ADDENDUM No. 3

City of Austin

Project Name: Todd Lane Improvements from Ben White to Saint Elmo

C.I.P. No. 6755.002

CROSS SECTION A-A
NTS

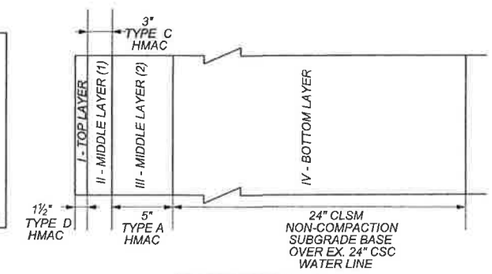
REV. NO.	BY	DATE	REVISION DESCRIPTION
1	EZ	4/17/13	ADDED DRWG. 3

SHEET NUMBER 37 OF 175

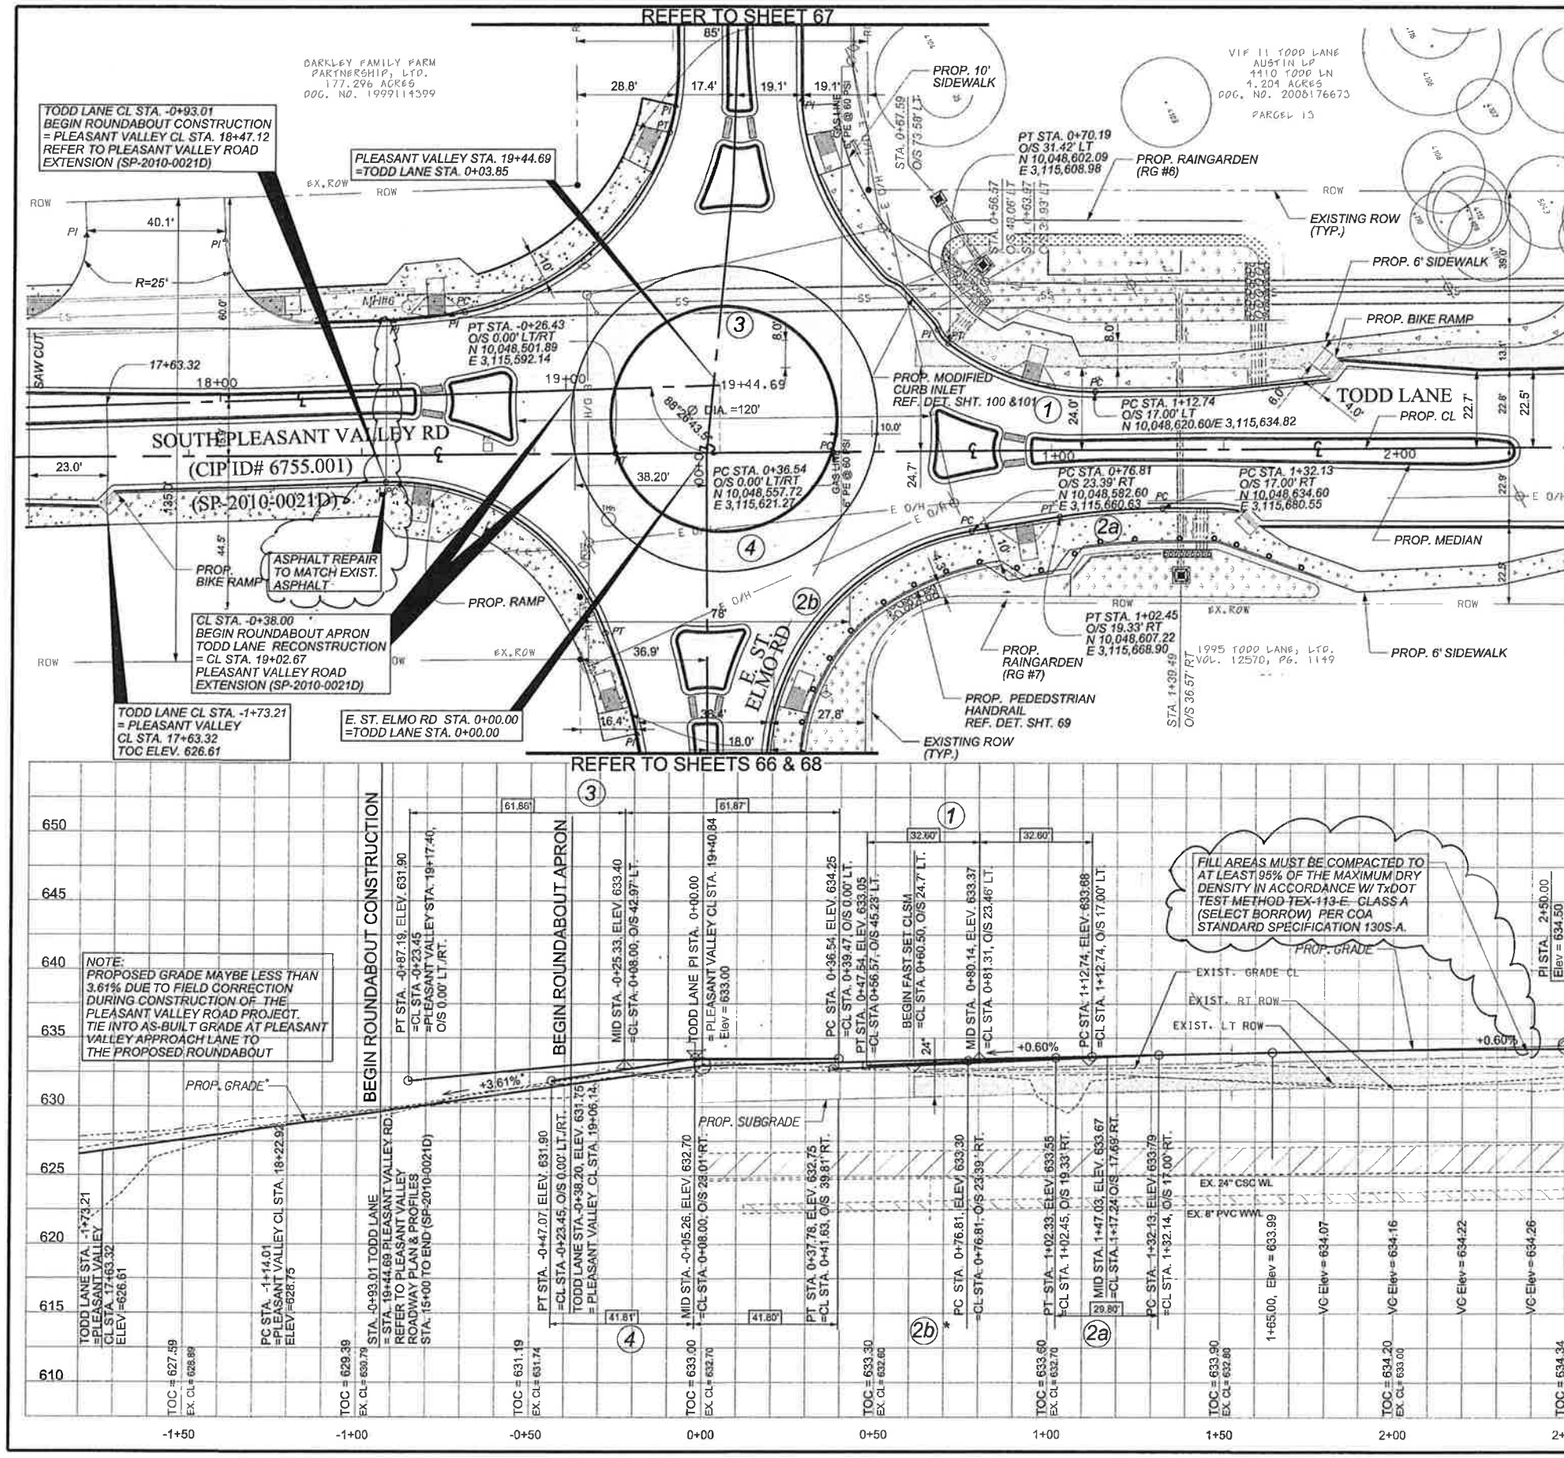
REV. NO.	BY	DATE	REVISION DESCRIPTION
1	C.E.	04/01/13	ADD NOTES - ADDENDUM #3

NOTE:
PROPOSED GRADE MAYBE LESS THAN 3.61% DUE TO FIELD CORRECTION DURING CONSTRUCTION OF THE PLEASANT VALLEY ROAD PROJECT. TIE INTO AS-BUILT GRADE AT PLEASANT VALLEY APPROACH LANE TO THE PROPOSED ROUNDABOUT

ROADWAY PLAN AND PROFILE
STA. 6+50 - 10+50

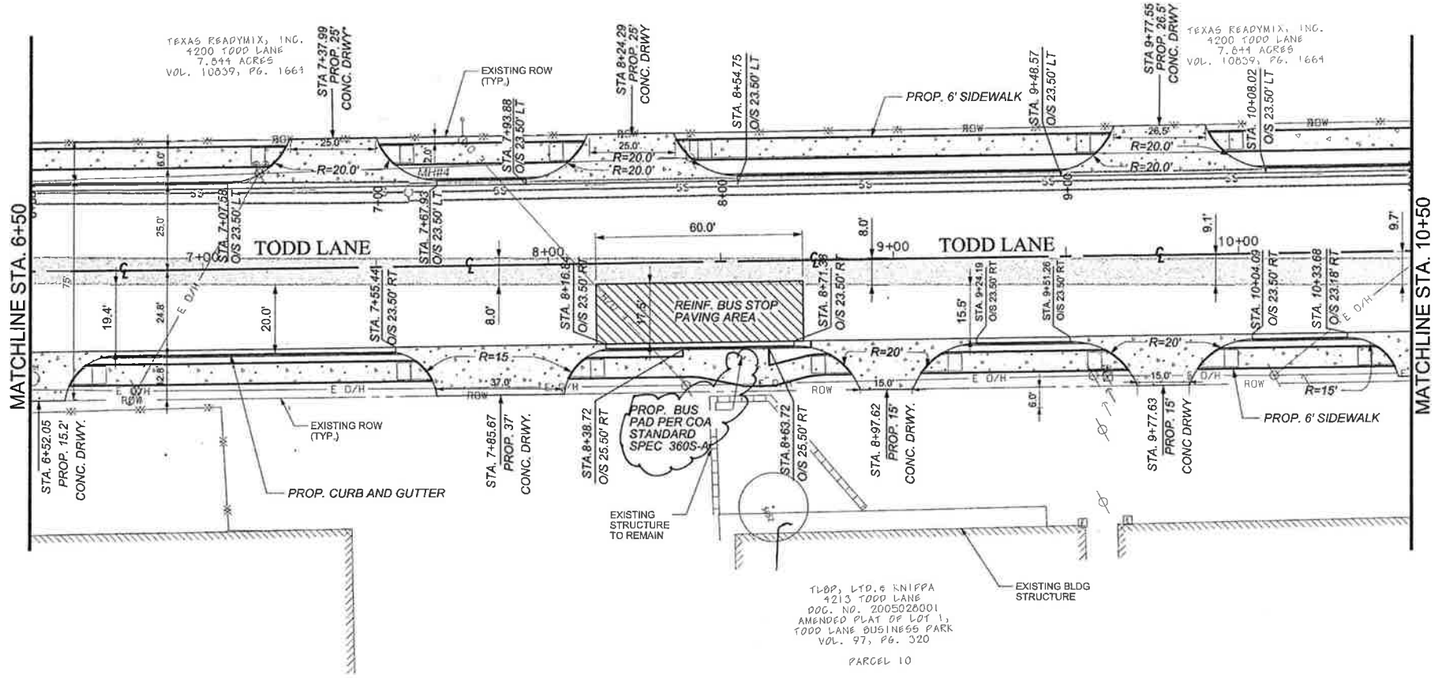
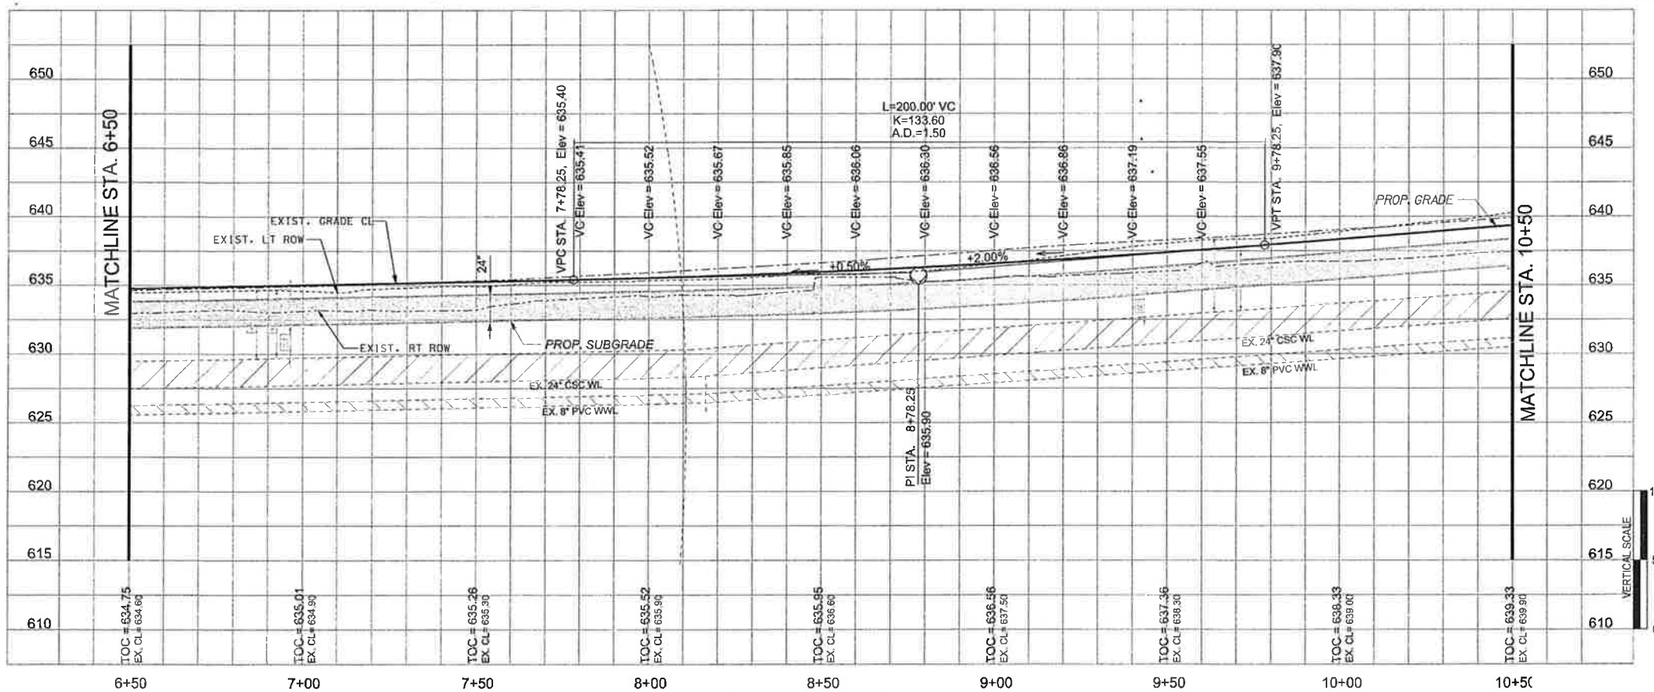
REV. NO.	BY	DATE	REVISION DESCRIPTION
1	EZ	04/16/13	ADD NOTE - ADDENDUM 3

NOTE:
REFER TO LANDSCAPE IRRIGATION SHEETS FOR LANDSCAPE IRRIGATION SLEEVES.

PROPOSED ROUNDABOUT LAYOUT AND GRADING PLAN

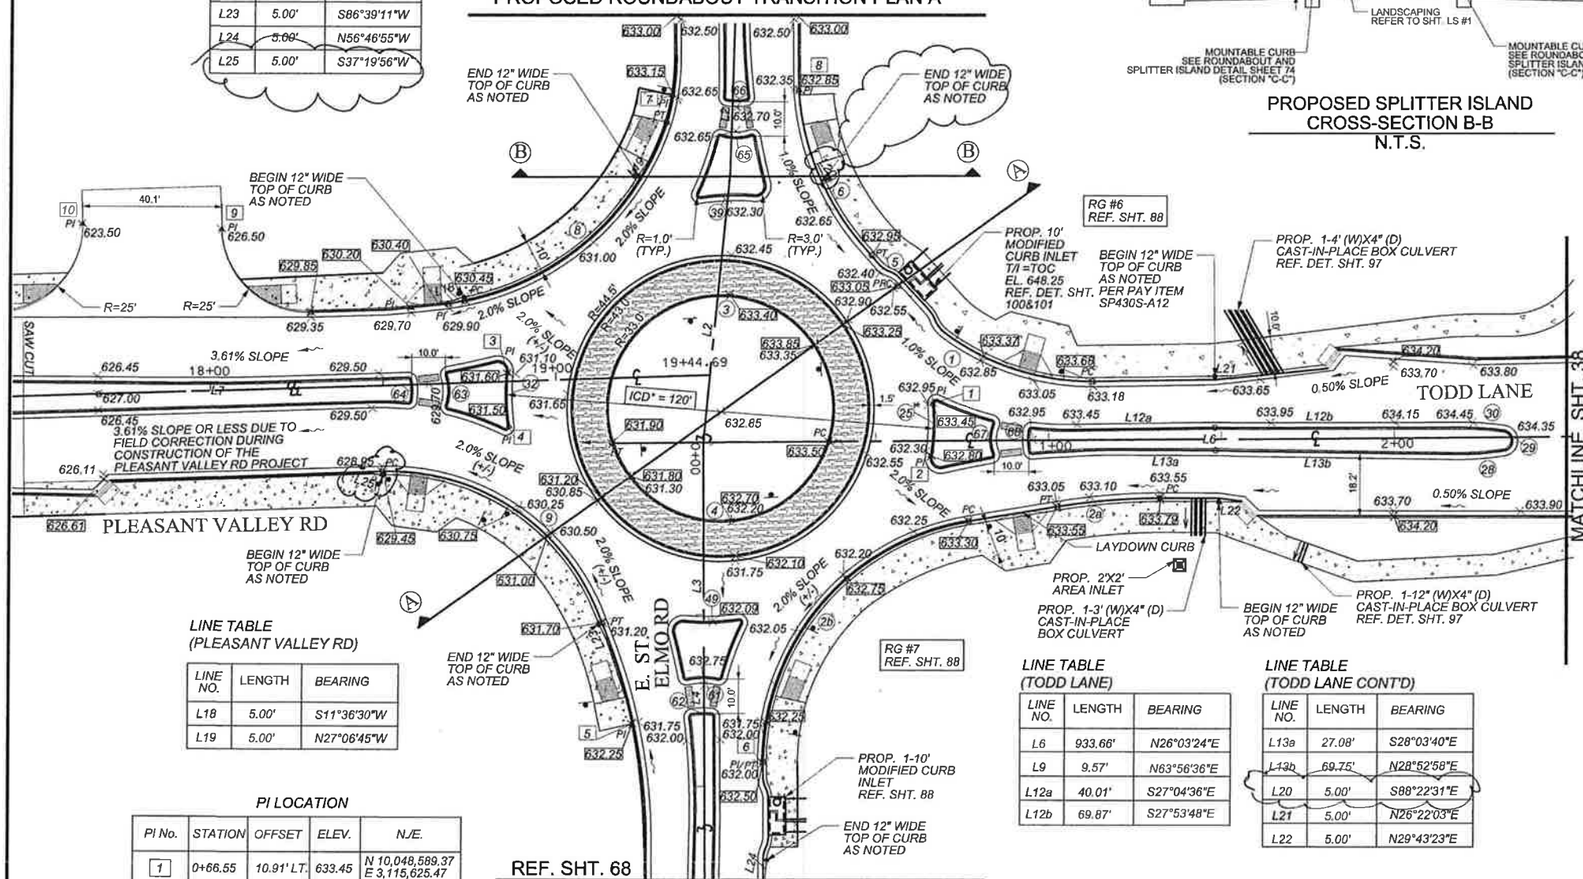
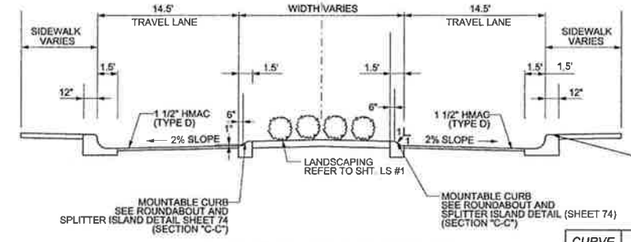
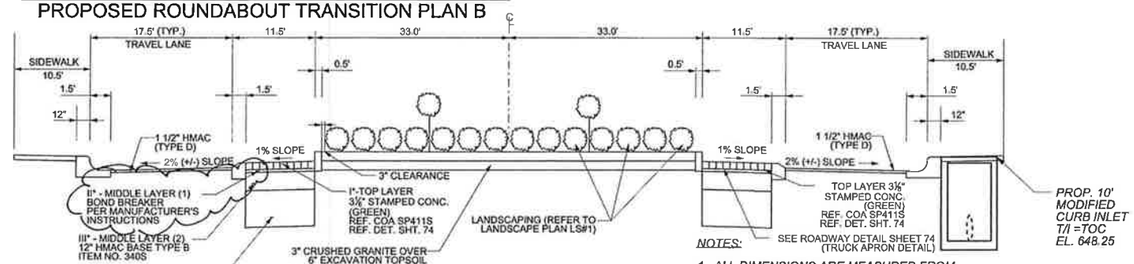
REV. NO.	BY	DATE	REVISION DESCRIPTION
1	CG	04/17/13	ADD NOTE - MODIFIED L13 & RANGE L20&L25

NOTE:
WIDEN TYPICAL TOP OF CURB FROM 6" TO 12" AS NOTED ON THIS PLAN.

CONSTRUCTION DETAILS OF ROUNDABOUT
PROPOSED ROADWAY DETAILS SHEET 6

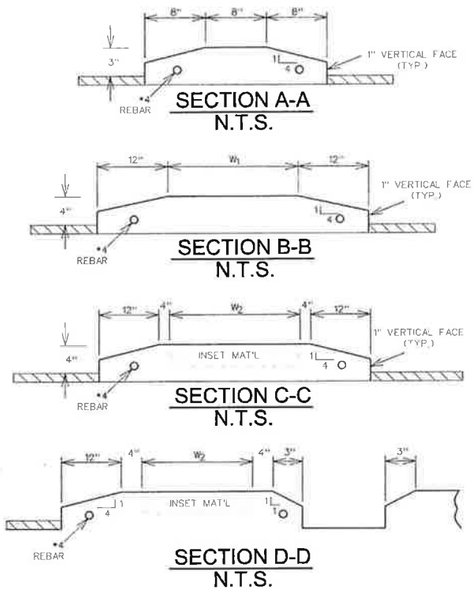
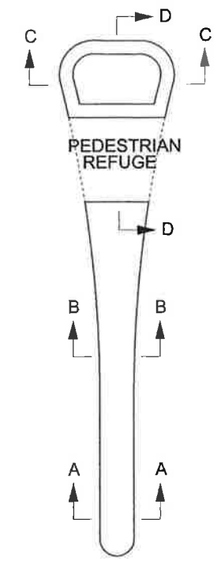
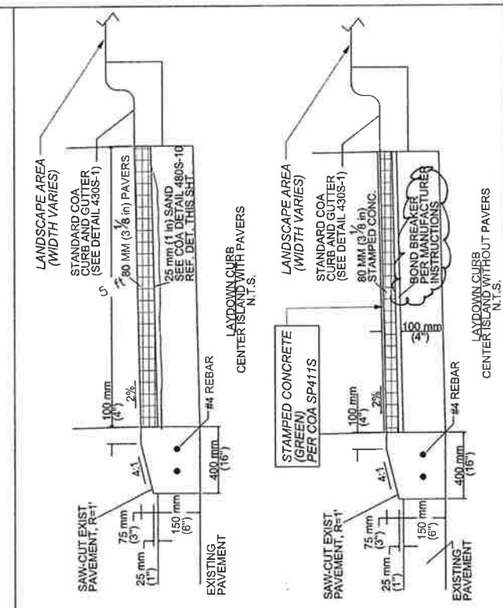
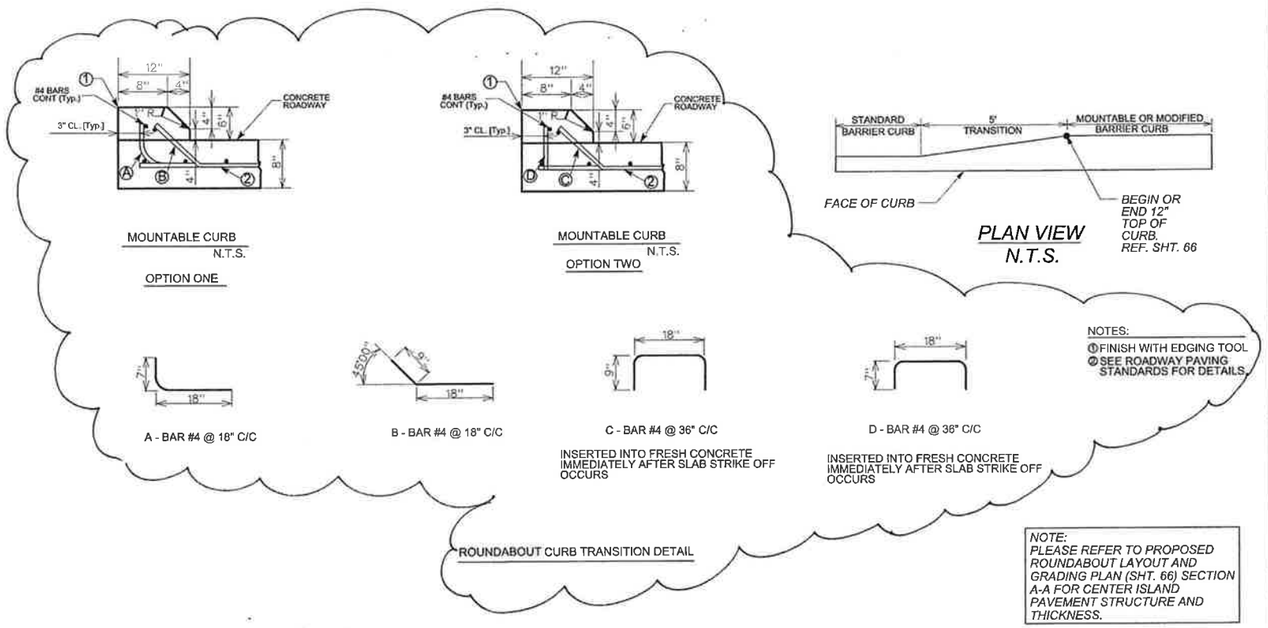
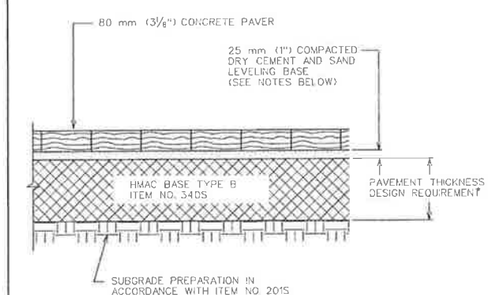
REV. NO.	BY	DATE	REVISION DESCRIPTION
1	EZ	04/17/13	ADD NOTE & DETAILS - ADDENDUM #3

NOTE:
PLEASE REFER TO PROPOSED ROUNDABOUT LAYOUT AND GRADING PLAN (SHT. 66) SECTION A-A FOR CENTER ISLAND PAVEMENT STRUCTURE AND THICKNESS.

WATER LINE PLAN AND PROFILE
STA. 0+00 - 1+90

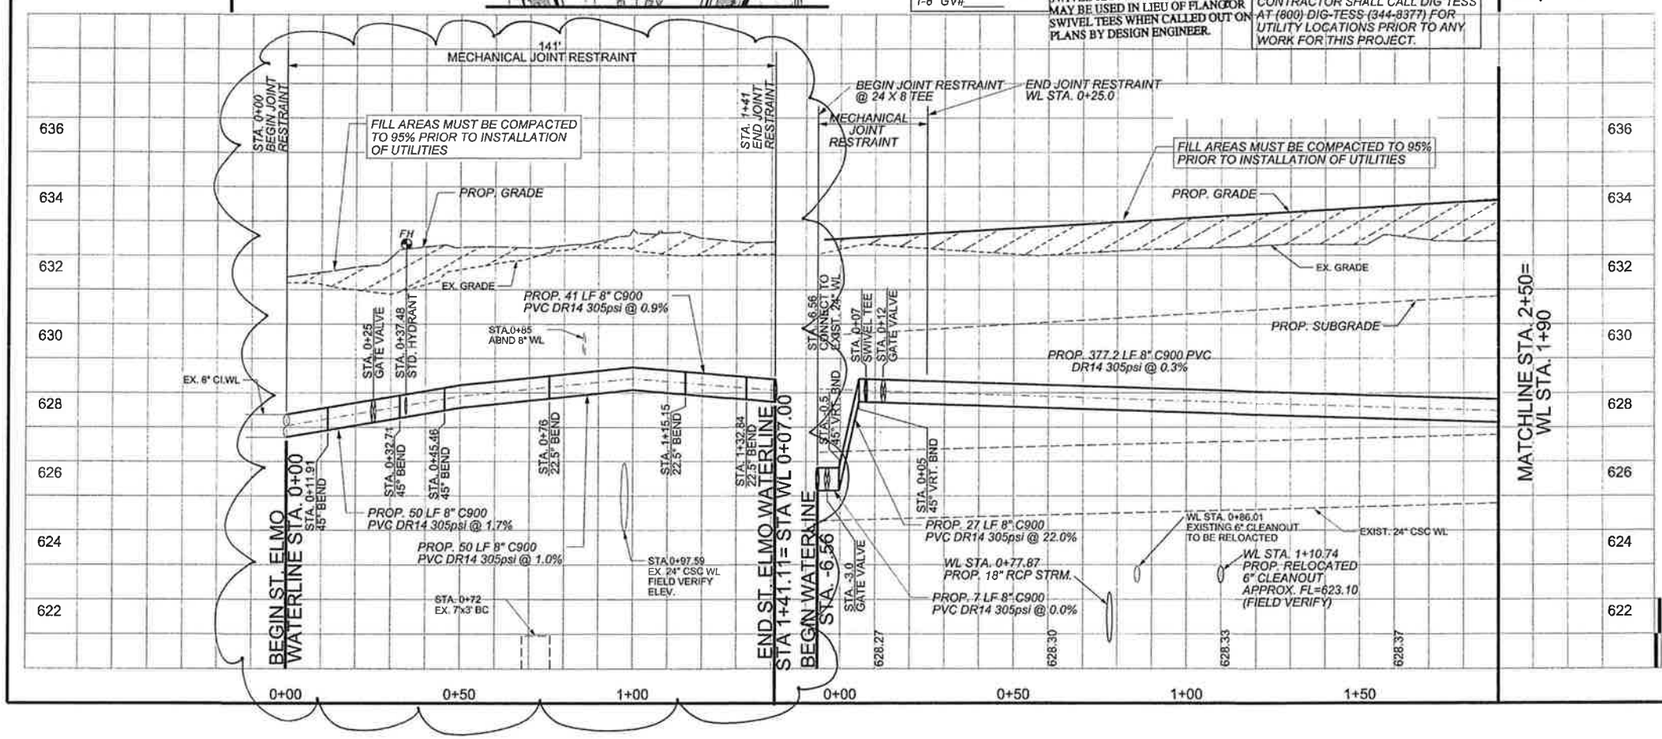
REV. NO.	BY	DATE	REVISION DESCRIPTION
1	EZ	4-17-13	WATERLINE MODIFICATION ADDENDUM 3
